We sincerely thank you for your valuable comments and constructive suggestions. We have substantially revised the manuscript to address all the concerns raised in the review. First, we expanded the methodology section by adding further details on the model formulation, numerical implementation, configurable parameters, and coupling with the land-surface model. Second, we refined the WRF physical parameterization configuration by adopting the vegetation-dependent scheme for surface thermal roughness length over land and repeated the simulations. The revised configuration improved the baseline performance of WRF_CTL, while the inclusion of the PV coupling scheme further improved the simulation performance. We also updated the reanalysis dataset used for model evaluation by adopting the higher-resolution CLDAS dataset at a spatial resolution of 0.0625° . Third, we clarified the distinction between WRF-PV and previous modeling approaches by conducting an additional effective albedo experiment and directly comparing the different implementations. We redrew all the figures and repeated the diagnostic analyses, although the PV-induced effects were similar to those in the previous version.

Figure R1: Mean diurnal cycle of the WRF_PV–WRF_CTL difference in 2 m air temperature (T2, °C) averaged over D03 and WRF PV grid cells during the summers of 2018–2024. Shaded areas represent the 95 % confidence intervals based on $\text{mean} \pm 1.96 \times \text{standard error}$.

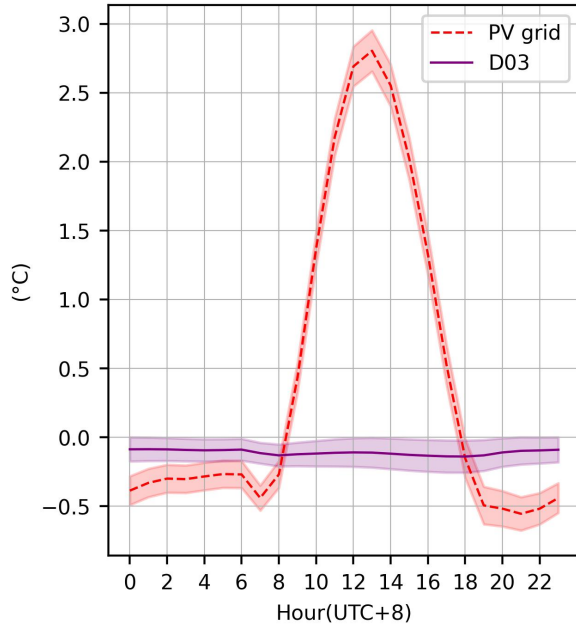
General Suggestions 1-1: Section 4.1 serves as validation of the model implementation. However, the comparison mainly focuses on regional mean, and the difference between the PV run and the control run is so small that I doubt whether it is noise from internal variability. From my expectation, I would see larger difference when averaged only over PV regions. In this case, how is the model-simulated T and precipitation compared to the observed ones?

Response: Thank you for this important comment. We additionally evaluated T2 and precipitation on the CLDAS reanalysis grids over PV installations. WRF_PV produced a T2 bias of $+1.72^\circ\text{C}$ and an RMSE of 2.40°C , compared with $+1.64^\circ\text{C}$ and 2.47°C , respectively, in WRF_CTL. The comparable positive biases in WRF_PV and WRF_CTL suggest that the absolute warm bias may largely reflect systematic biases shared by both WRF simulations. For precipitation, WRF_PV produced a bias of -0.01 mm day^{-1} and an RMSE of 0.661 mm day^{-1} , compared with $+0.05\text{ mm day}^{-1}$ and 0.735 mm day^{-1} in WRF_CTL. Thus, WRF_PV showed a precipitation bias closer to zero and a lower RMSE over the PV regions. Please note that the evaluation in Section 4.1 was based on 0.0625° CLDAS grid cells containing PV installations, whereas the differences between WRF_PV and WRF_CTL in Section 4.2 were calculated over the 3 km WRF PV grid cells. Figures R1 and R2 compare the responses over the entire D03 domain and WRF PV grid cells. The T2 response was substantially stronger over the PV grid cells (Fig. R1). At each hour of the diurnal cycle, the WRF_PV minus WRF_CTL difference from each day was treated as one sample, and a t-test was used to determine whether the mean difference was significantly different from zero. The precipitation frequency distribution showed larger differences over the PV grid cells (Fig. R2).

Figure R3: Probability density distributions of skin temperature (TSK, °C) errors for the WRF_PV (blue shade) and WRF_CTL (red shade) simulations with respect to MODIS observations. The vertical dashed line denotes zero error. (Figure 4 in the revised manuscript)

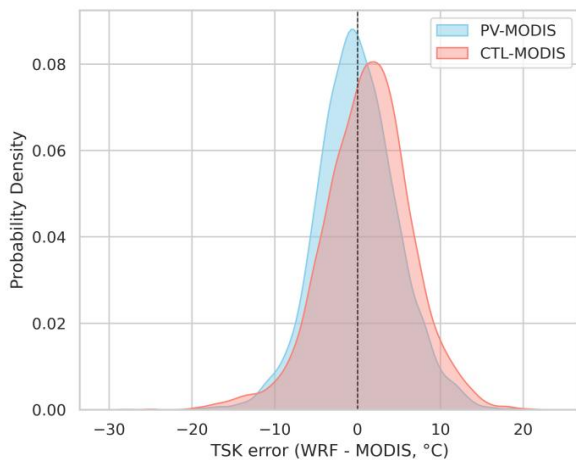
General Suggestions 1-2: While section 4.1.3 presents simulated skin temperature compared against MODIS- observed skin temperature only over the PV grid cells, the difference of the probability distribution is still very small, and there are still a substantial number of samples that have very large bias above 5 K.

Specific Point 30: Figure 5: x-axis label and unit are missing. What does the blue vertical line mean?

Response: Thank you for this helpful comment. In response to your suggestion, we refined the physical parameterization configuration and repeated the simulations. Figure R3 shows that TSK errors in WRF_PV are more concentrated near zero, whereas WRF_CTL is shifted toward positive errors. The relatively large errors in some individual samples may arise from differences in the timing and representation of short-term weather processes, because skin temperature responds rapidly to changes in cloudiness and surface solar heating (Wang et al., 2014; Trigo et al., 2015). Such differences can produce large errors at individual MODIS overpass times. We also added an analysis of the mean bias values and recalculated the evaluation statistics by first averaging TSK over all PV grid cells at each MODIS observation time and then calculating the statistics across the 77 observation times. WRF_CTL showed a mean bias of +0.697 °C and an RMSE of 3.071 °C, whereas WRF_PV showed a mean bias of −0.340 °C and an RMSE of 2.560 °C. Thus, WRF_PV reduced the RMSE by 0.511 °C and decreased the magnitude of the mean bias. These results indicate improved agreement with MODIS for TSK over the PV installations.

“A total of 10,310 valid 8-day MODIS–WRF collocations were retained and used to construct the error distributions shown in Fig. 4. The WRF_PV errors were more concentrated near zero, whereas the WRF_CTL distribution was shifted toward positive errors. At each observation time, MODIS LST and WRF TSK were first averaged over all valid PV grid cells. Bias and RMSE were then calculated from the 77 paired time-mean samples. WRF_CTL produced a mean bias of +0.697 °C and an RMSE of 3.071 °C, whereas WRF_PV produced a mean bias of −0.340 °C and an RMSE of 2.560 °C. Thus, WRF_PV reduced the RMSE by 0.511 °C and reduced the magnitude of the mean bias relative to WRF_CTL. These results indicate that WRF_PV achieved better agreement with MODIS than WRF_CTL over the PV installations.”

Response: Thank you for pointing this out. In the revised manuscript, the former Figure 5 has been renumbered as Figure 4. We have added the x-axis label and unit, and clarified that the vertical dashed line denotes zero TSK error ($\text{WRF} - \text{MODIS} = 0\text{ °C}$) (Fig. R3).

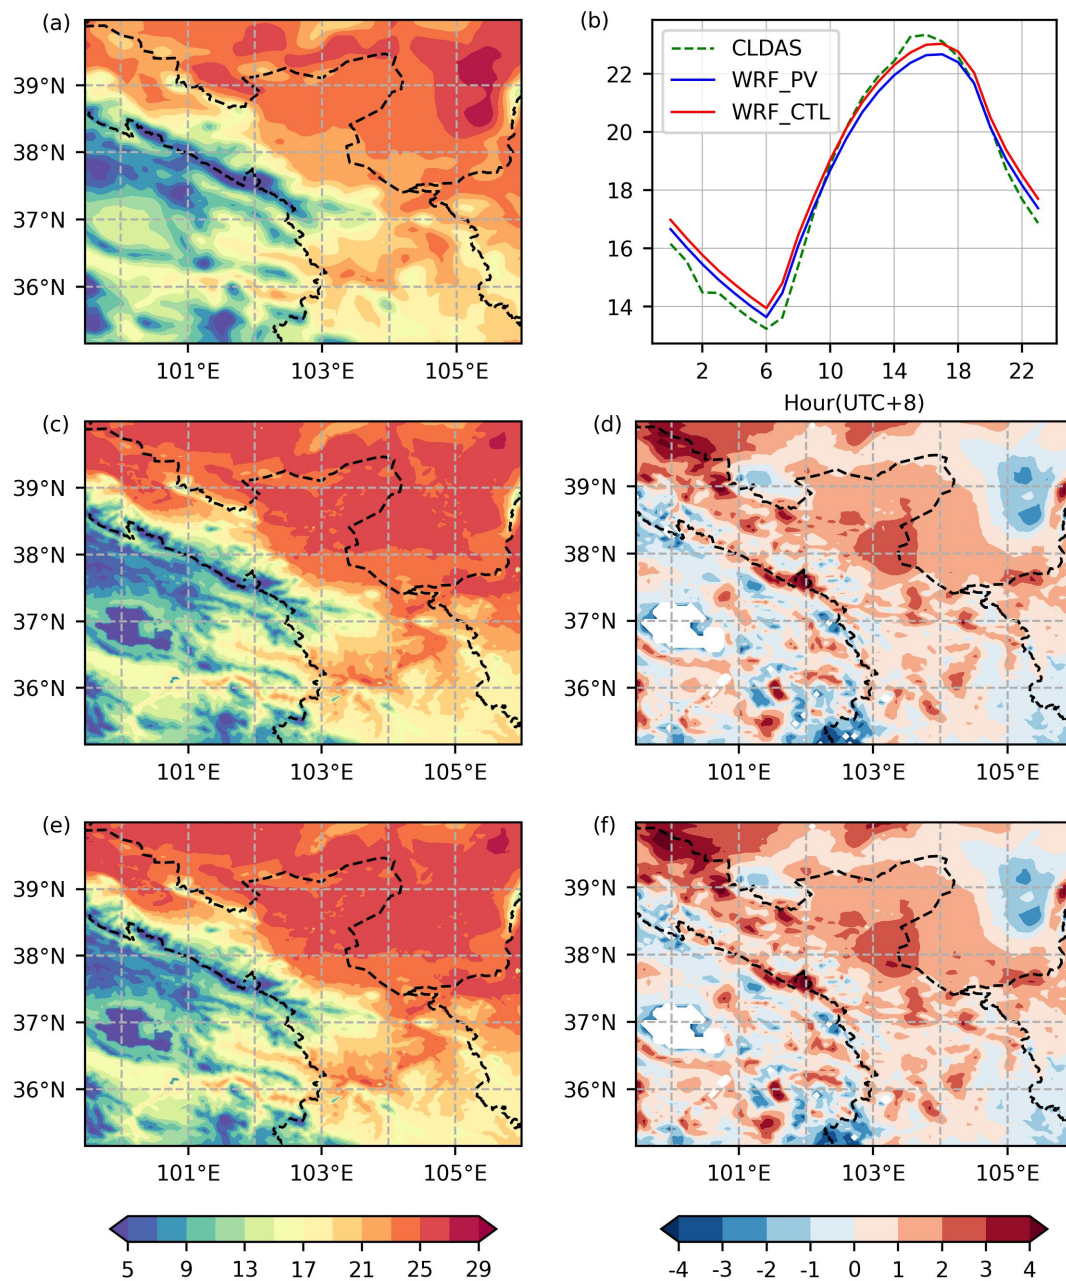
Specific Point 26: Figures 2 and 3: please add bias maps (model – CMFD) since the spatial pattern panels alone do not show where the errors lie.

Response: Thank you for this suggestion. We have replaced CMFD with the higher-resolution CLDAS dataset at a spatial resolution of 0.0625° for model evaluation. We have added model – reanalysis bias maps to the revised figures to show the spatial distribution of model errors more clearly (Fig. R4, R5).

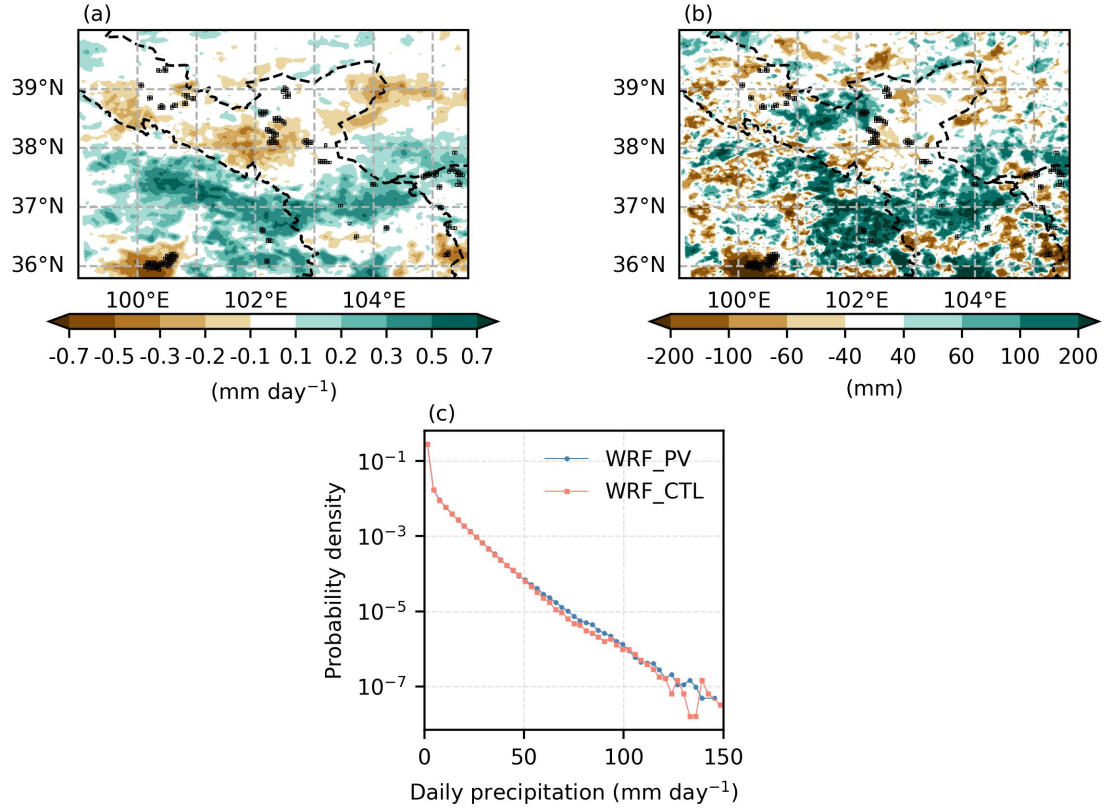
Specific Point 37: Figure 10: Explain the elements of the box plot. What is the red curve? Also it is important to note that all differences are statistically insignificant. Maybe examine the spatial pattern of the extreme-precipitation change so that we can see whether it is correlated with PV location, downstream of it, or essentially noise?

Response: Thank you for this helpful suggestion. We have removed the original Figure 10, including the box plot and the red curve. We replaced it with two spatially explicit figures to examine the precipitation changes and their associated atmospheric conditions more directly.

Figure R6 presents the spatial differences in mean precipitation and cumulative extreme precipitation ($>30 \text{ mm day}^{-1}$, following the definition of CMA) between WRF_PV and WRF_CTL, together with the probability distributions of daily precipitation. Although the domain-mean precipitation difference was small, the spatial response was pronounced. Precipitation generally increased over the central and southern parts of the domain and decreased over several northern and western areas. Accumulated extreme precipitation showed a more localized spatial response than mean precipitation. WRF_PV also showed a slightly higher probability density for heavy rainfall of $60\text{--}100 \text{ mm day}^{-1}$, suggesting a modest shift toward more intense rainfall events.

“Figure 9 shows the spatial distributions of the changes in daily mean and cumulative extreme precipitation between WRF_PV and WRF_CTL together with the probability density distributions of daily precipitation. The domain-mean precipitation difference between WRF_PV and WRF_CTL was small, indicating little change in the overall summer precipitation amount (Fig. 9a). However, the spatial response was pronounced, with precipitation increasing mainly over the central and southern parts of the domain and decreasing over several northern and western areas. Despite only small changes in mean precipitation (Fig. 9a), the related changes in water vapor convergence, vertical motion, and precipitation were dynamically coherent (Fig. 10c and 10d). This precipitation response pattern was broadly consistent with the period difference in the reanalysis data (Fig. S1). Accumulated extreme precipitation showed a more distinct and localized spatial response than mean precipitation (Fig. 9b). The probability distributions of WRF_PV and WRF_CTL were generally similar for light and moderate rainfall. However, WRF_PV showed a slightly higher probability density for heavy rainfall of 60–100 mm day⁻¹, suggesting a modest shift toward more intense rainfall events (Fig. 9c). A broadly similar shift in the daily precipitation distribution was also evident between the two periods in the reference dataset (Fig. S2).”
